CLIVE PLANNING & ZONING COMMISSION

RE: Site Plan Amendment - Tenant and Facade Updates - 10001 University Ave

Re: 10001 UNIVERSITY AVE - drive through and parking addition - Site Plan Amendment

SITE PLAN FOR:
10001 UNIVERSITY
CLIVE, IOWA

10001 UNIVERSITY
DIMENSION PLAN

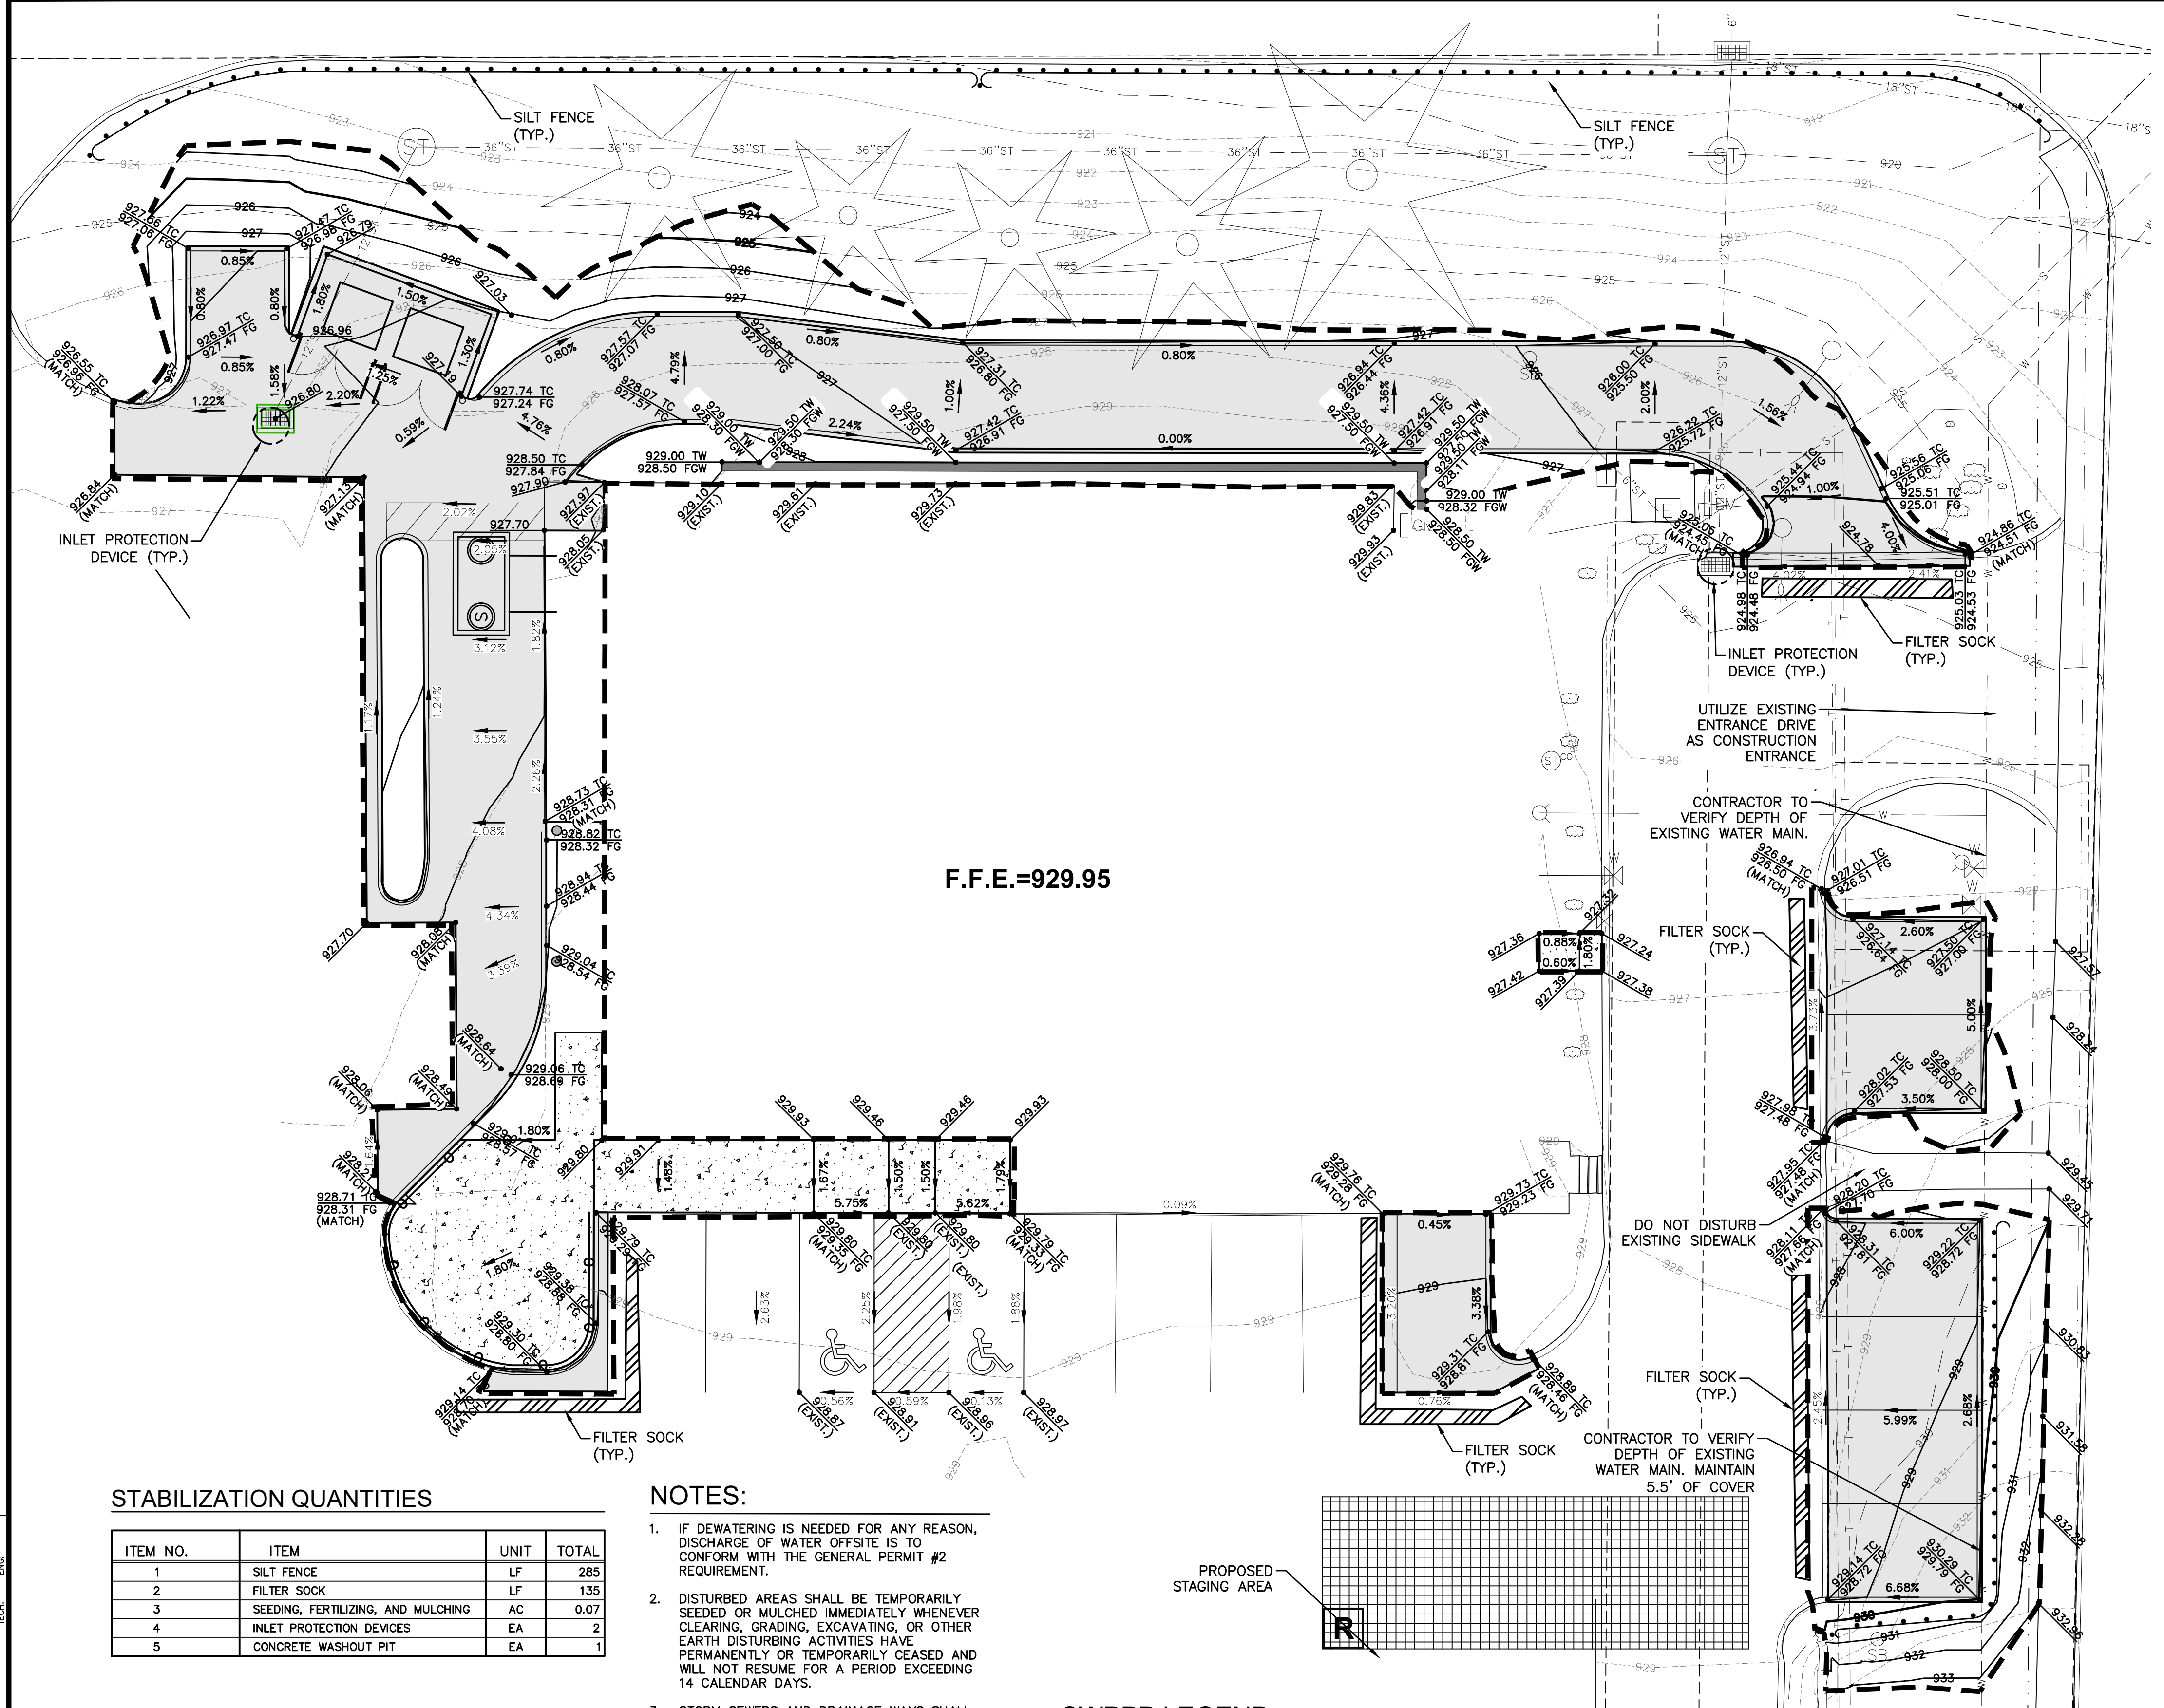
1. Identify the 5' parking lot setback along the private drive. Staff did not locate the setback.

1. Adjust the corner of the north sidewalk and drive-through intersection OR verify existing sidewalk pavement is sufficient to withstand regular vehicle crossing and no elevation change exists.

2. Clearly identify the existing property line and clearly label the proposed property line.
3. Adjust the railing around the patio to be setback at least 2' from the edge of the parking stall to accommodate vehicle door swing OR adjust parking stall striping to maintain a 12' stall width.

4. Identify pre-treatment/permanent protection to be installed for the intake near the dumpster enclosure.
5. Identify the 5' parking lot setback along the private drive.

6. Update the relocated pole light label to reflect "Parking Lot Light" and label the mounting height. Additionally, indicate either (1) fixture to match existing or (2) the manufacturer and model number for the proposed light fixture.

7. Identify the water, sanitary, and storm easement at Book 5473 Page 697.
8. The proposed use requires an exterior grease interceptor; identify location on the site plan amendment. Contact Jason Merk with the WRA at JMERK@DMGOV.ORG for additional information on sizing requirements.

9. Drive thru median must be a curbed island, not painted.

10001 UNIVERSITY
GRADING PLAN

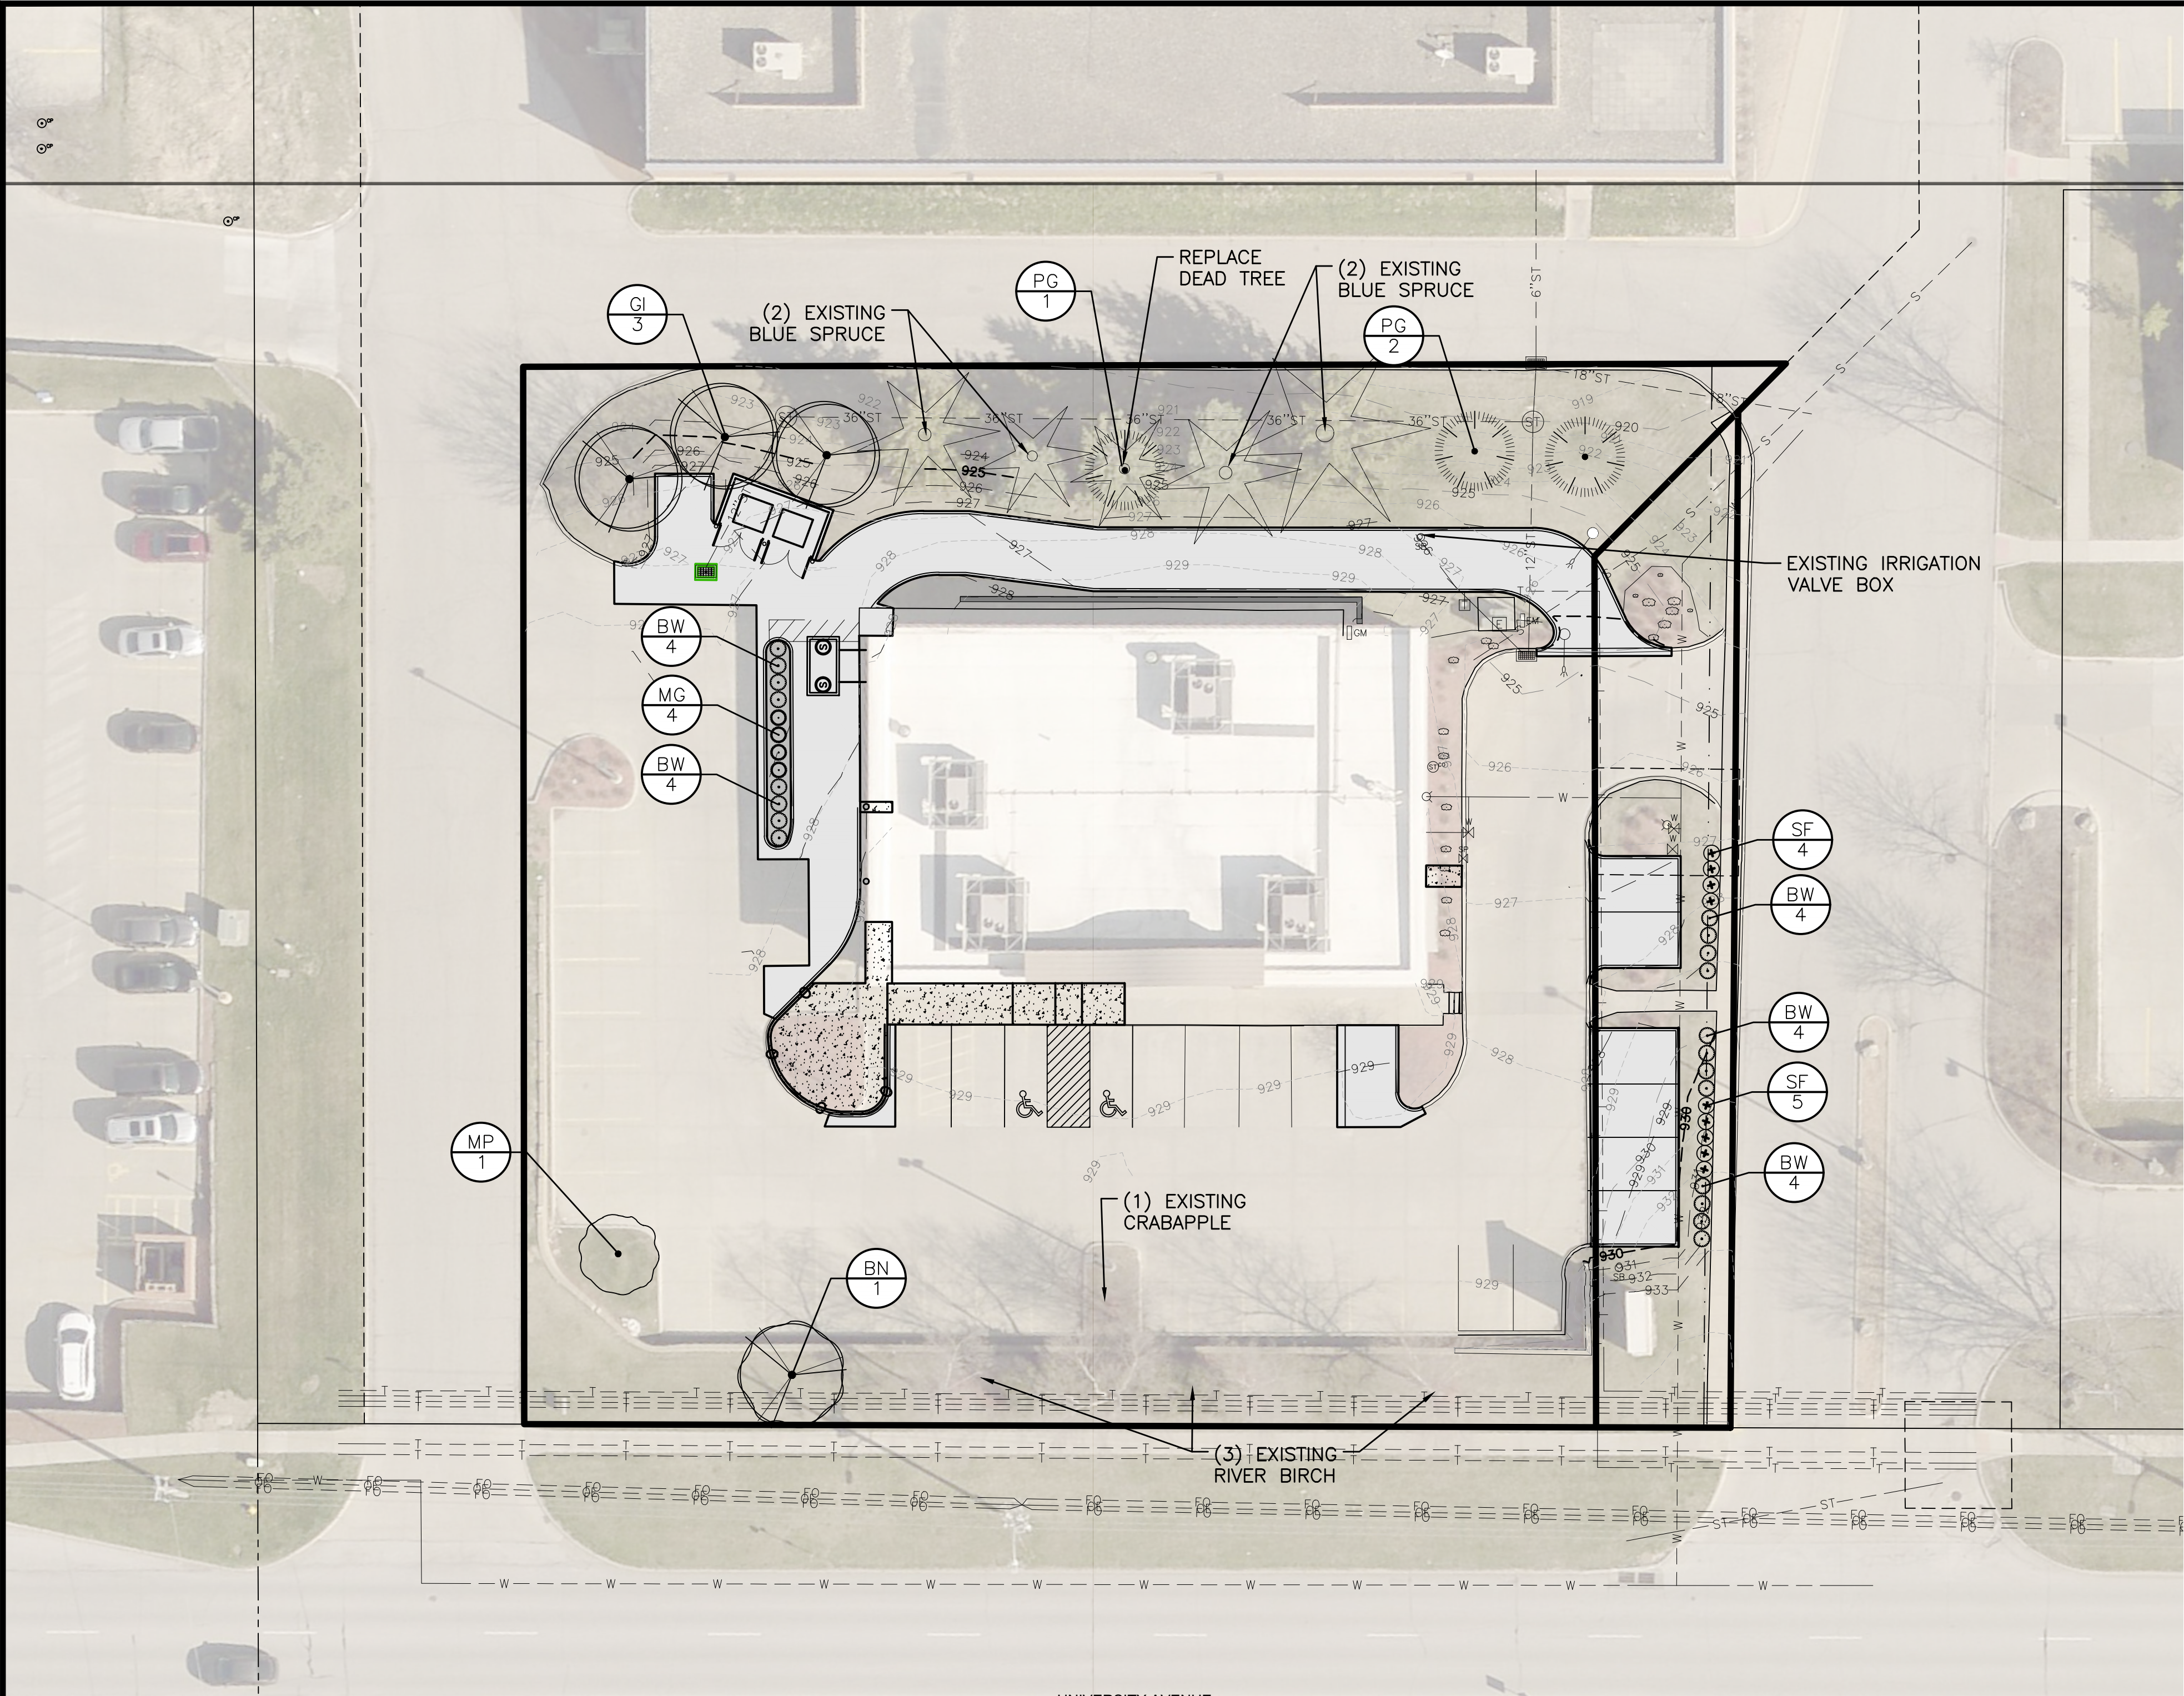
1. Add a note to maintain a minimum 5.5' of cover for the existing water main and service line. Staff did not locate the note.

1. Add a note to maintain a minimum 5.5' of cover for the existing water main and service line.
